# Work Order ID 73074

Item Name: Crosstube Turning Detail

DRAWING NO. D212-664-241	TITLE CROSSTUBE ASSY (205/212 HI AFT)	REV. D	DART AEROSPACE LTD ENGINEERING ORDER		D.E.O. NO. D212-664-241-D-1	SHEET NO. SHEET 1 OF 2	SCALE NTS
DRAWN	CHECKED	MFG. APPR.	APPROVED	DE APPR.			
DATE 11.04.07	DATE 11.04.11	DATE 11.04.12	DATE 11/04/12	DATE 11.04.12

DRAWING NO. D212-664-241	TITLE CROSSTUBE ASS'Y (205/212 HI AFT)	REV. D	DART AEROSPACE LTD ENGINEERING ORDER		D.E.O. NO. D212-664-241-D-2	SHEET NO. SHEET 1 OF 1	SCALE NTS
DRAWN <i>Q</i>	CHECKED <i>ASS</i>	MFG. APPR. <i>DS</i>	APPROVED <i>MD</i>		DE APPR. <i>#</i>		
DATE 11.07.15	DATE 11.07.20	DATE 11.07.21	DATE 11.07.21		DATE 11.07.21

**D212-664-241/-241B  
ASSEMBLY DETAIL**

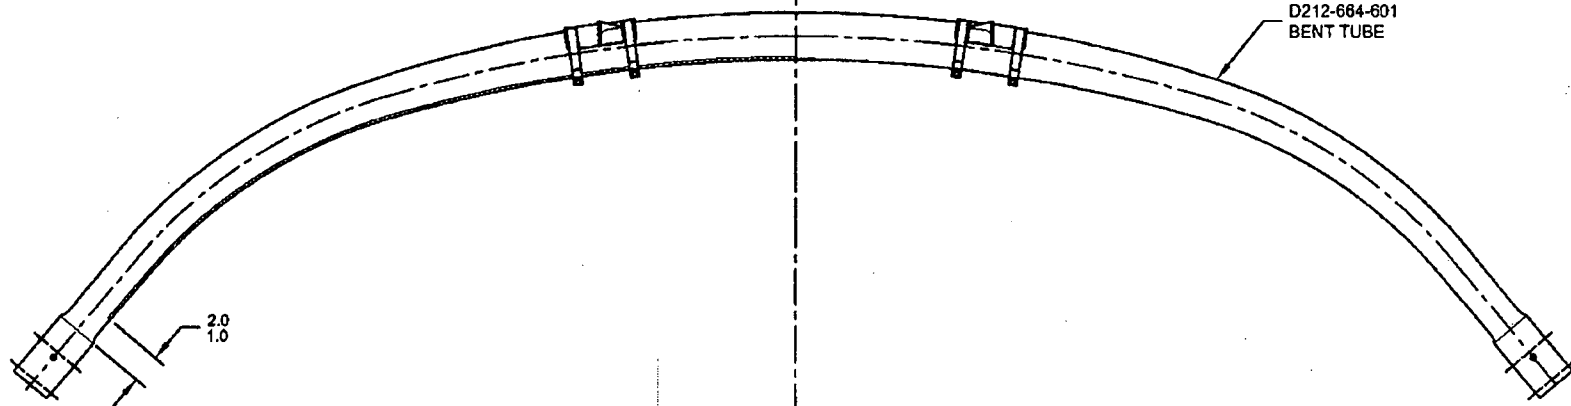
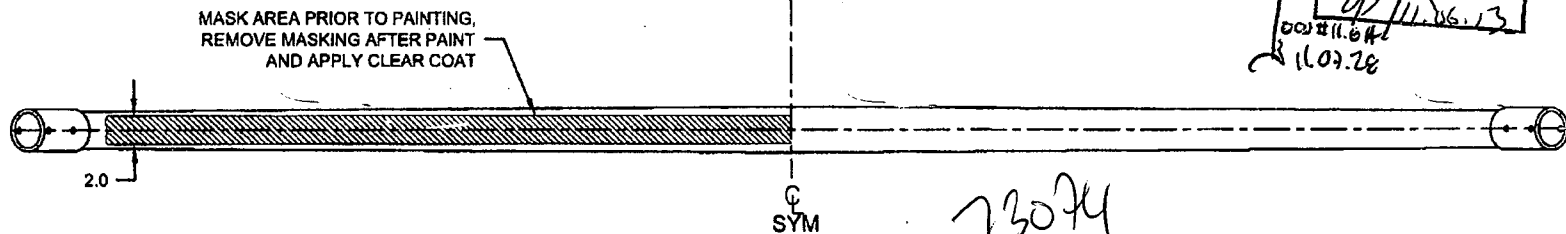
**PURPOSE:**

ADD AN INSPECTION WINDOW TO UNDERSIDE OF CROSSTUBE.

NOTES 2 OF SHEET 1 IS AMENDED AS FOLLOWS:

- 2) FINISH: CHEMICAL CONVERSION COAT PER DART QSI 005 4.1  
PRIME INSIDE AND OUTSIDE PER DART QSI 005 4.2  
MASK UNDERSIDE OF CROSSTUBE AS SHOWN (HATCHED AREA) AND  
PAINT OUTSIDE PER DART QSI 005 4.2  
REMOVE MASKING AND APPLY CLEAR COAT

- 2) FINISH: CHEMICAL CONVERSION COAT PER DART QSI 005 4.1  
PRIME INSIDE AND OUTSIDE PER DART QSI 005 4.2  
PAINT OUTSIDE PER DART QSI 005 4.2
